HOMOLOGATION AND TECHNICAL SPECIFICATION UPDATE BULLETIN

HOMOLOGATION	Rotax 125 DD2 MAX EVO	HOMOLOGATION NO.	114H
BULLETIN NO.	Rotax 4	BULLETIN DATE	23 March 2016

Figure 1.1: Original Support Plate (Part No. 651 060) to suit 125 DD2 MAX EVO Engines.

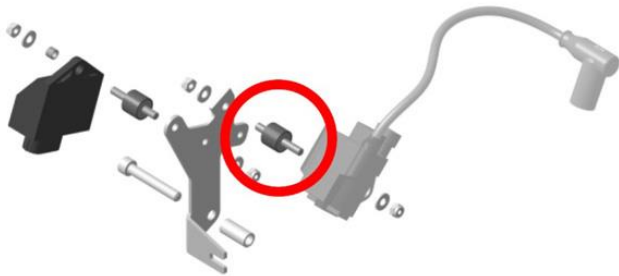
To minimize the vibration level of the electrical components BRP-Rotax have created a new Support Plate (Part No. 481 259) which carries the ECU, ignition coil and magnet valve in combination with the improved cable harness. Both the original support plate (Part No. 651 060) and the new support plate are legal.

Figure 1.2: New Support Plate (Part No. 481 259) to suit 125 DD2 MAX EVO Engines.
